Jones Gillam Renz Architects

The Residence at Green Meadow – JGR Proj 24-3395

ADDENDUM NO. 1

A3.2

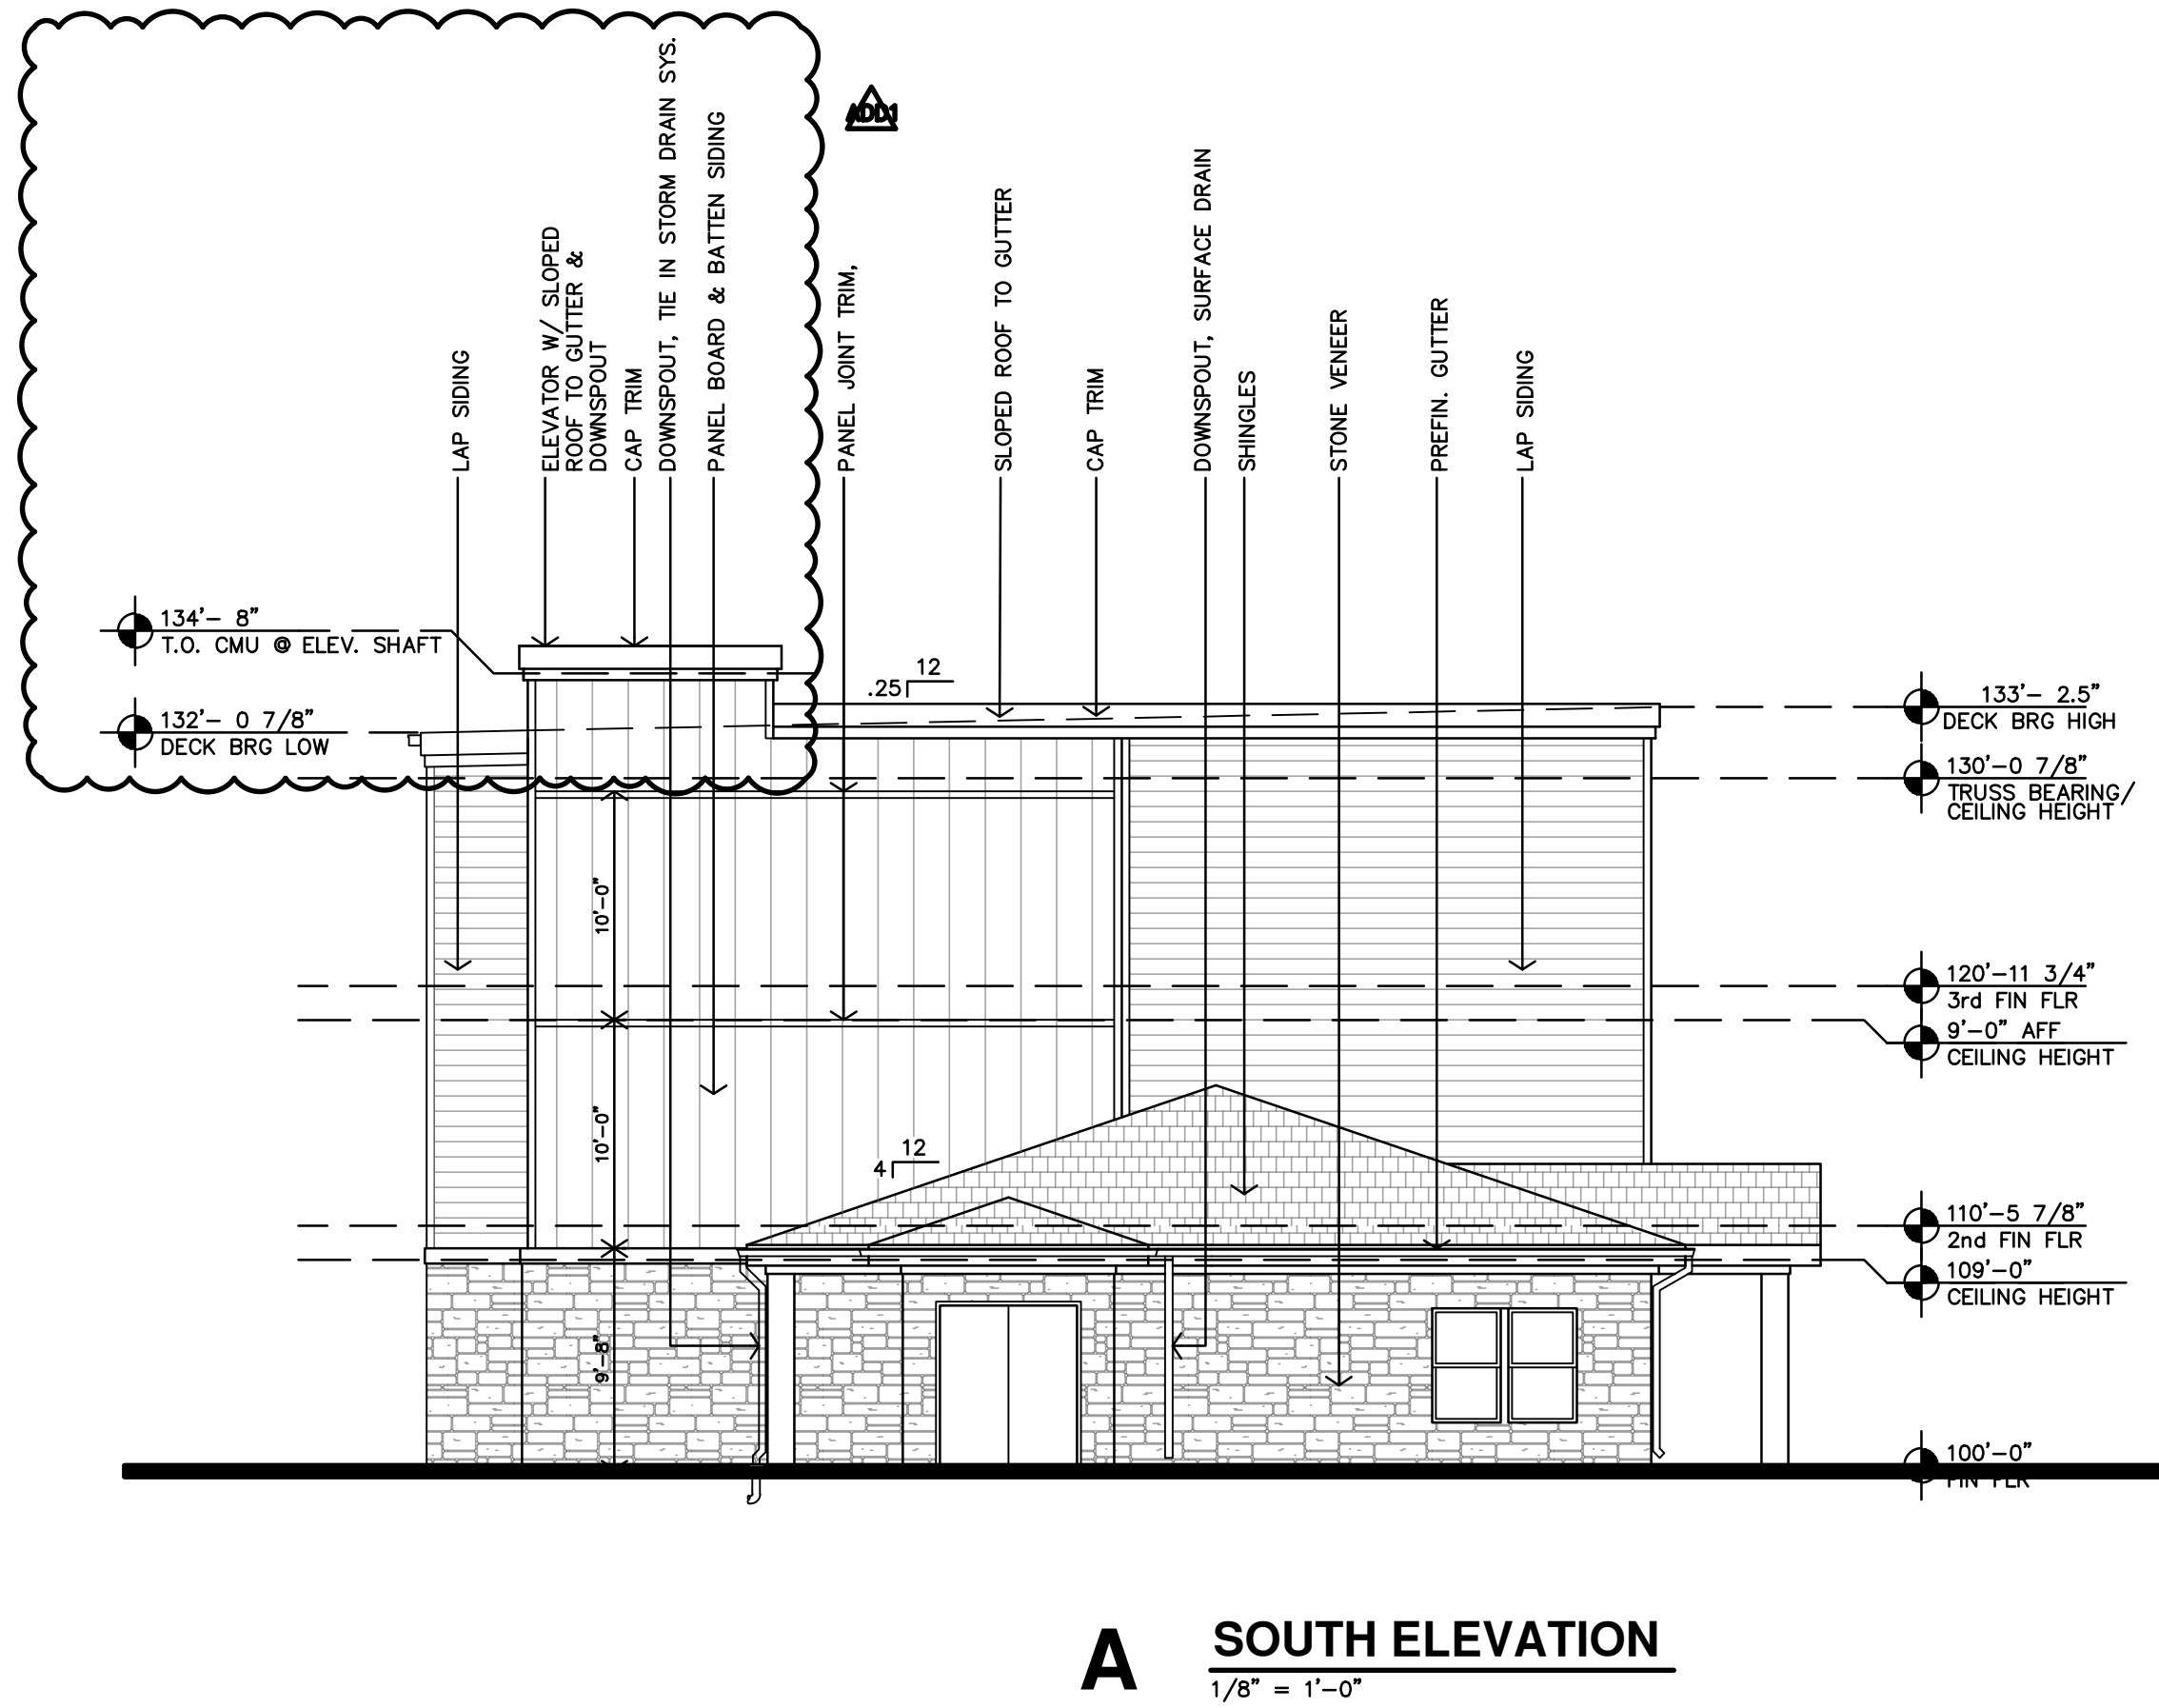
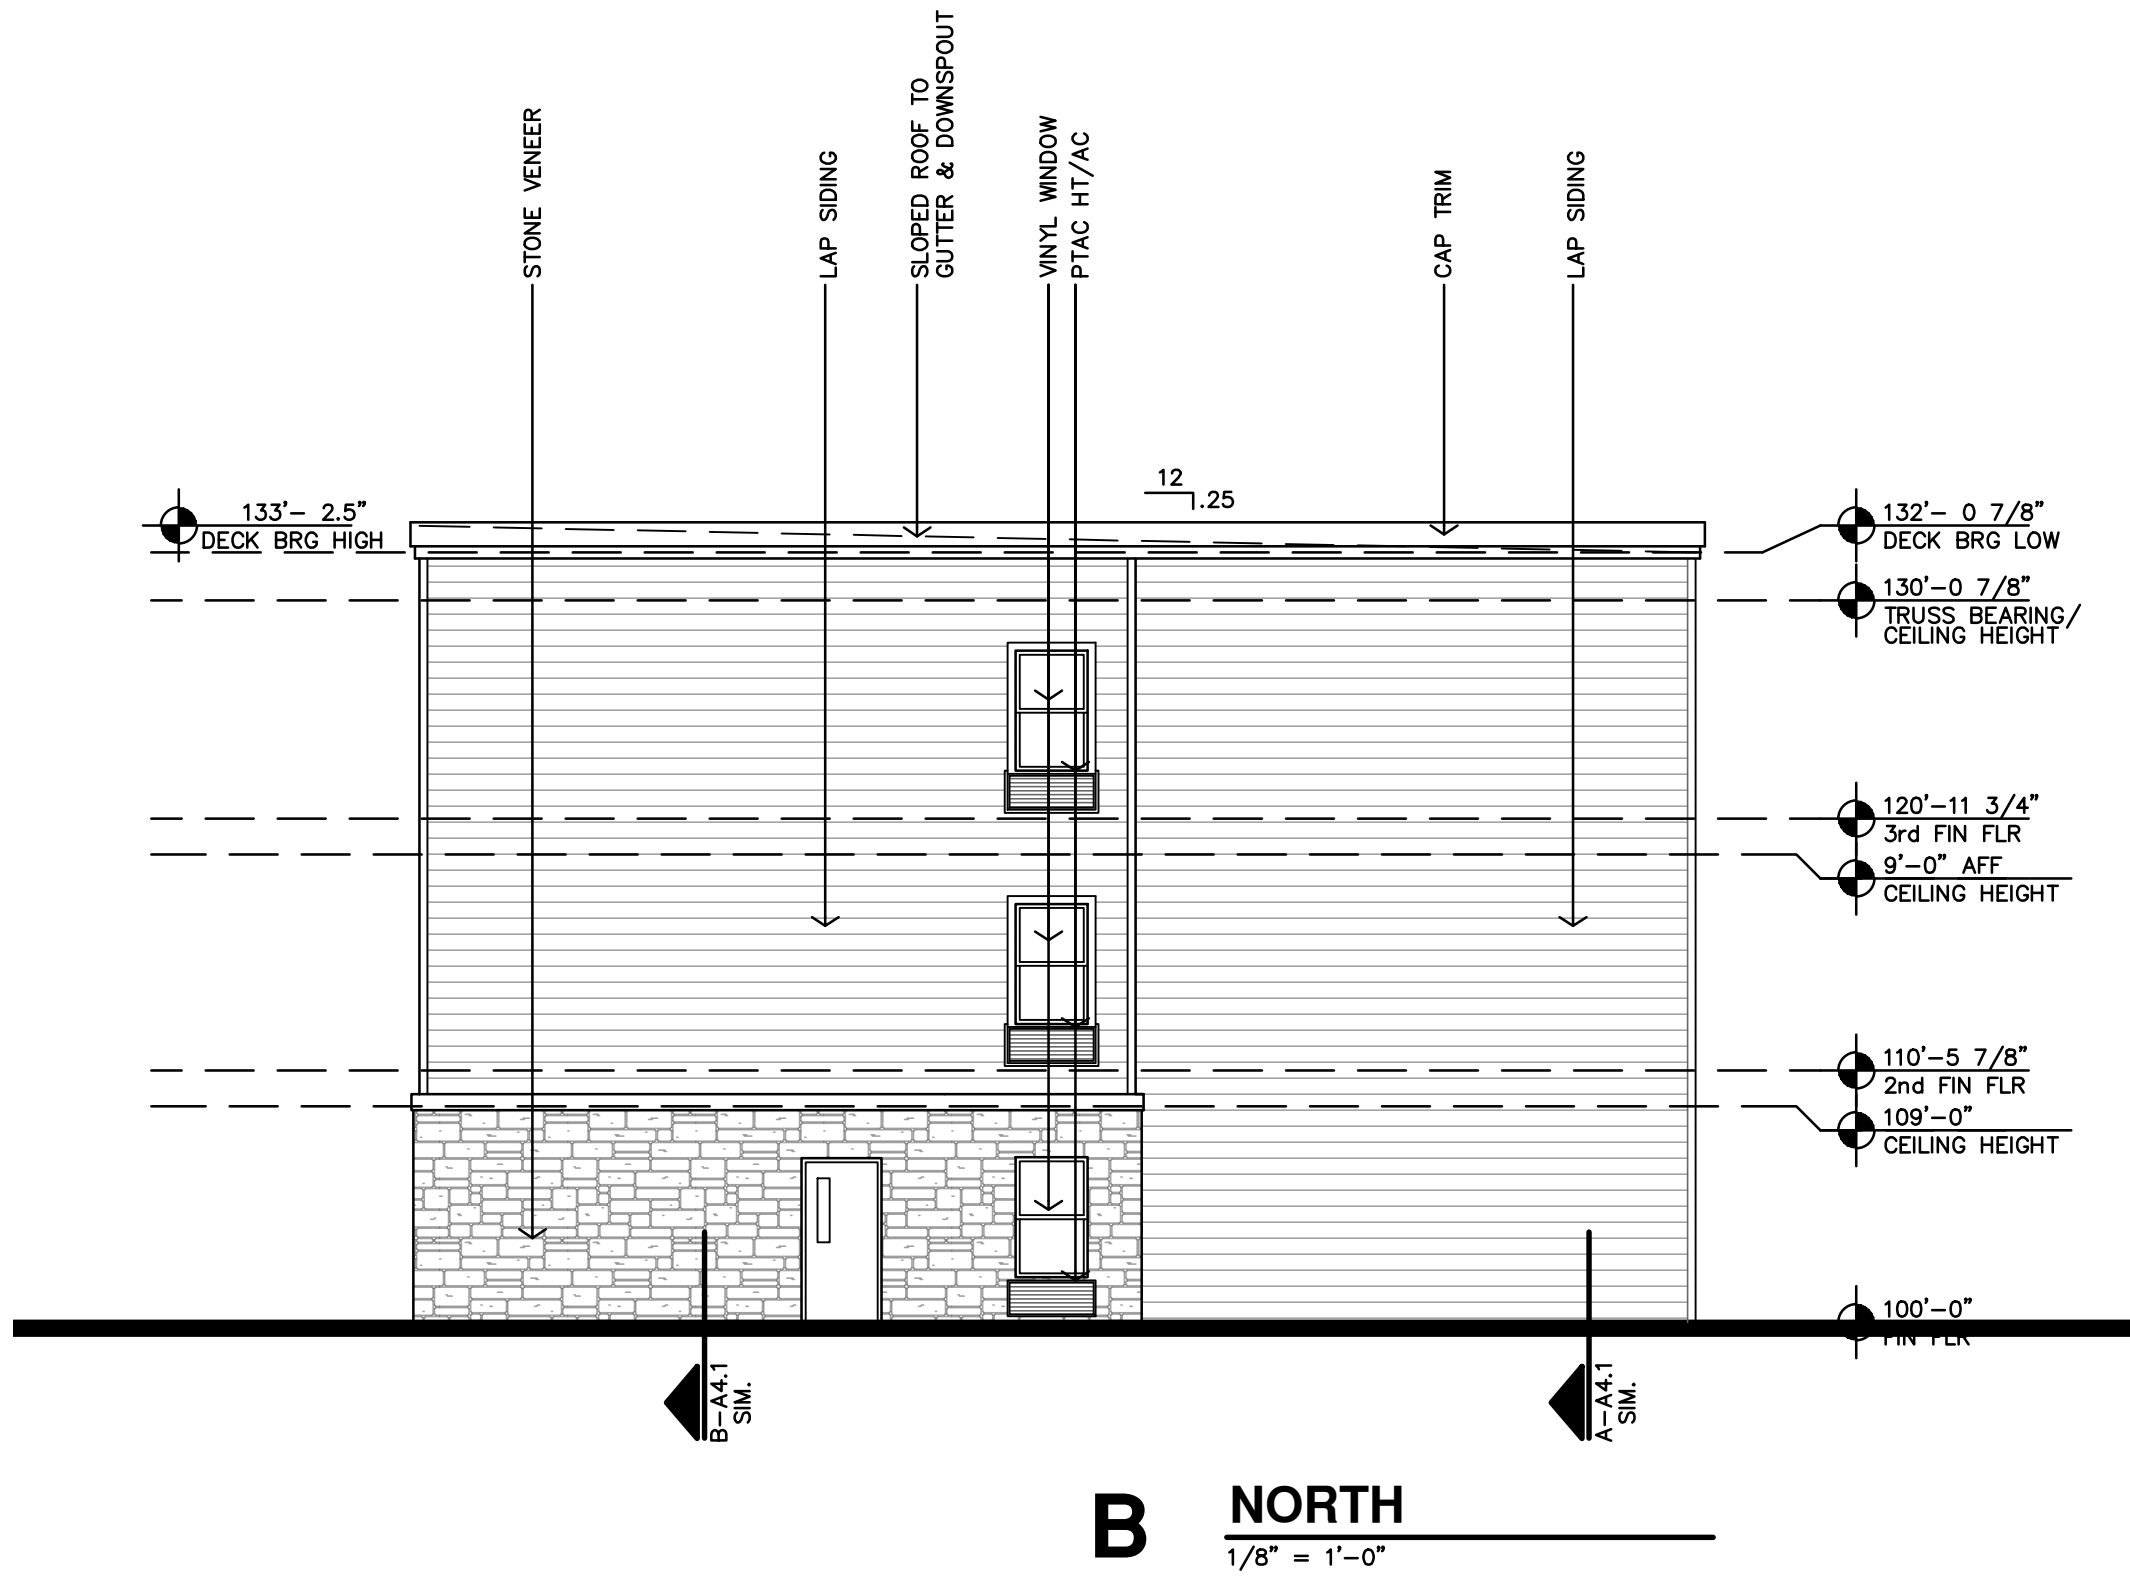
1. Sheet A3.1 – Roof/parapet at Elevator shaft adjusted to show roof sloping to drain onto low roof.
2. Sheet A3.2 – Roof/parapet at Elevator shaft adjusted to show roof sloping to drain onto low roof.
3. Sheet A5.1 – Roof slope changed to slope/drain to low roof vs. front of building. Gutter & downspout moved to opposite wall.
4. Sheet A6.2 – Roof slope changed to slope/drain to low roof vs. front of building. Gutter & downspout moved to opposite wall.

E1.1

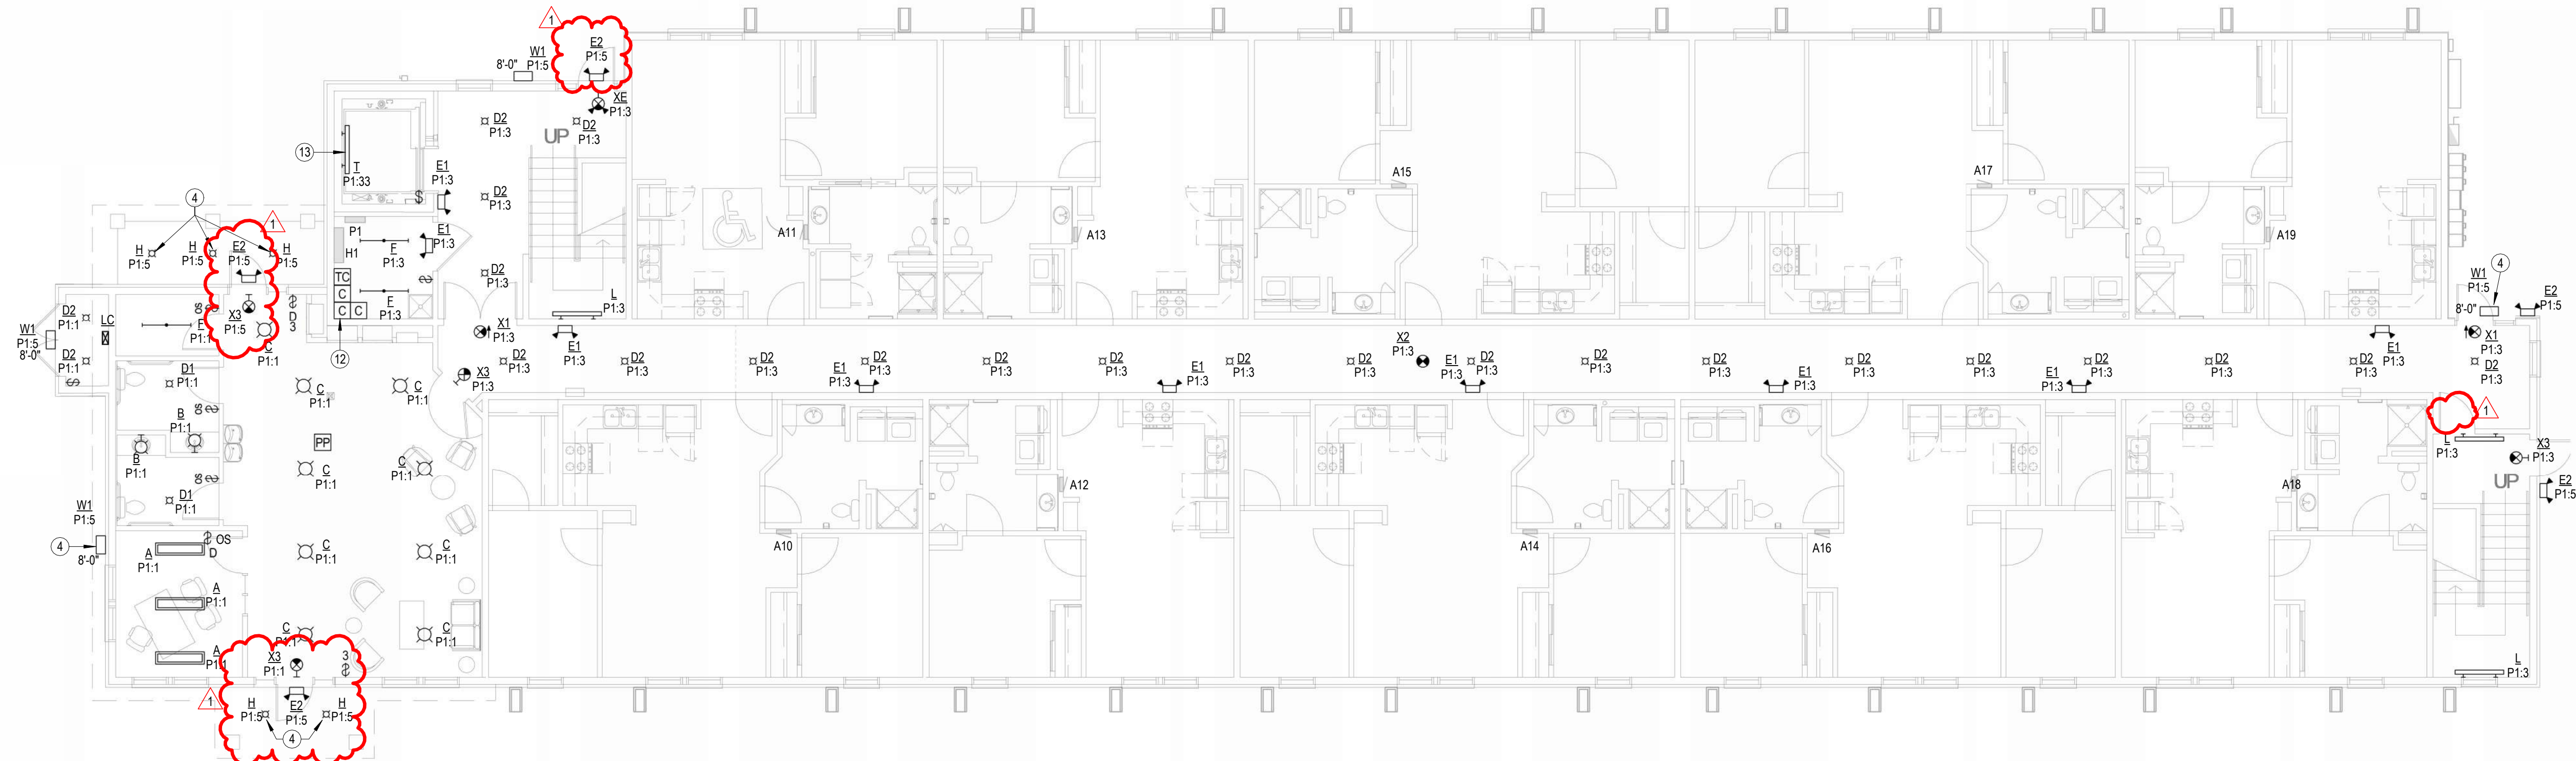
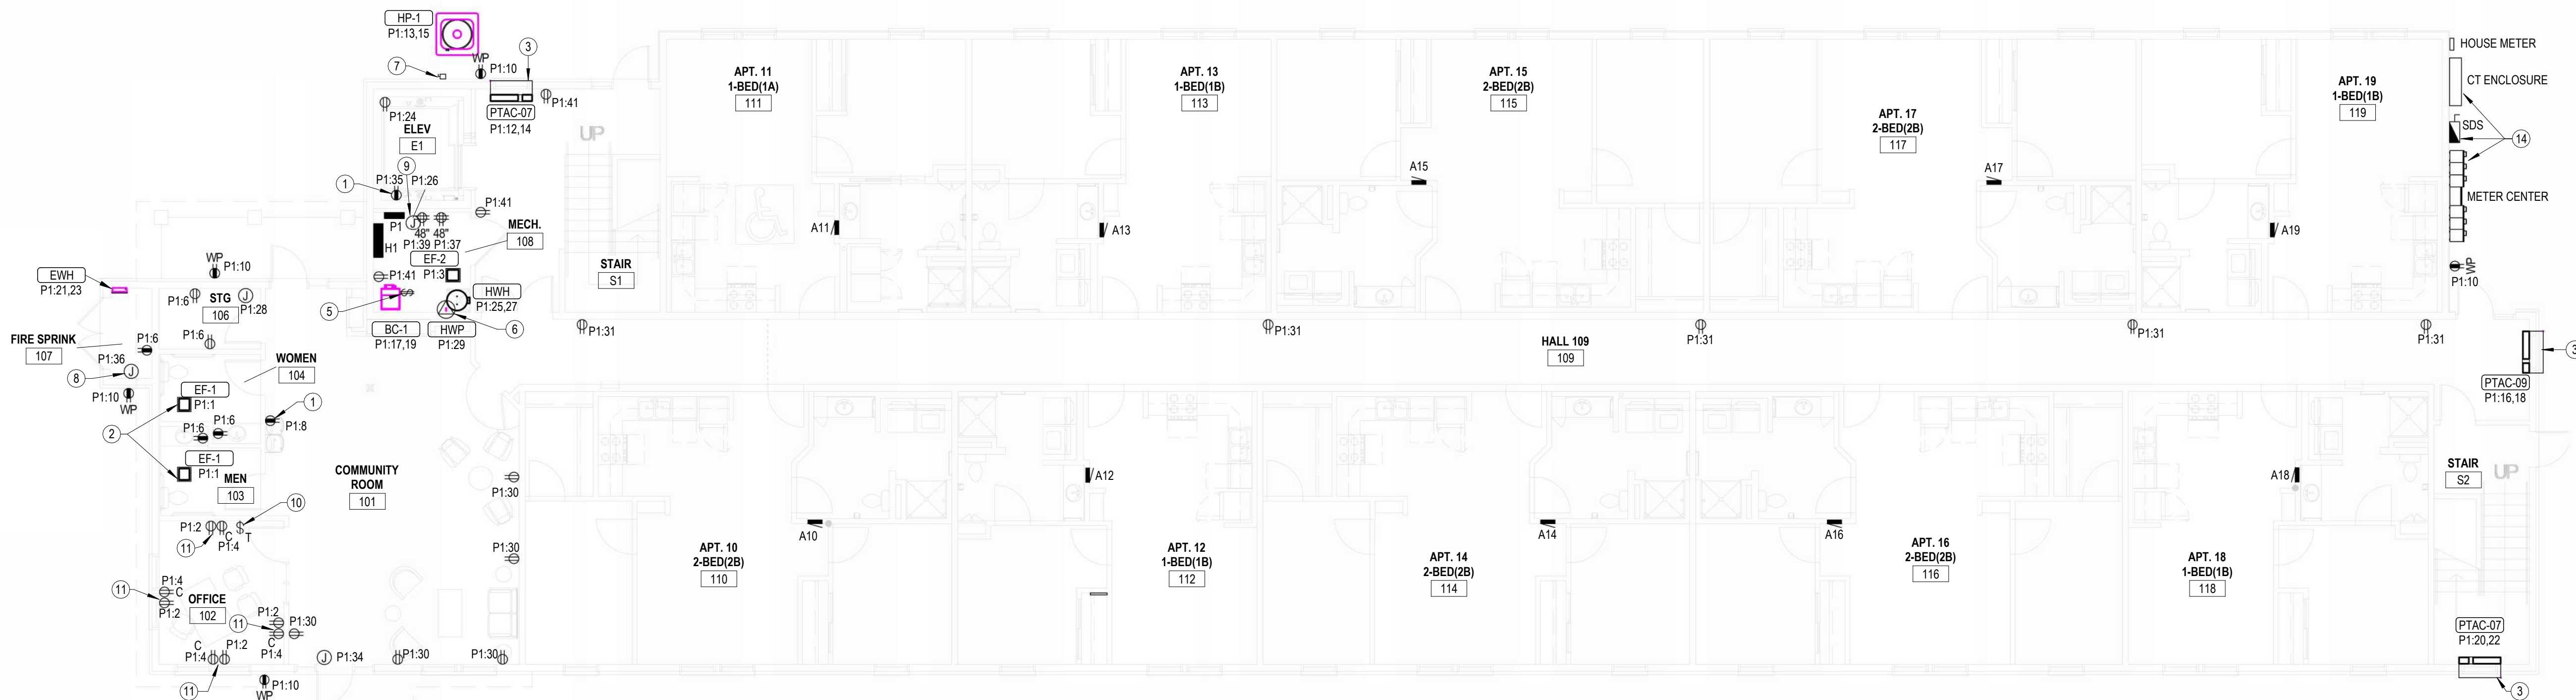
1. Sheet E1.1
 - a. Adjusted emergency and exit signs
 - b. Added IECC compliance note
2. Sheet E1.2 – Added IECC compliance note
3. Sheet E1.3
 - a. Added telecom conduit and notes

PROJECT SHALL COMPLY WITH ALL REQUIREMENTS OF 2021 IECC
-NOTE: OUTLET BOXES ON EXTERIOR WALL SHALL BE AIR-TIGHT
BOXES PER SECTION 402.6
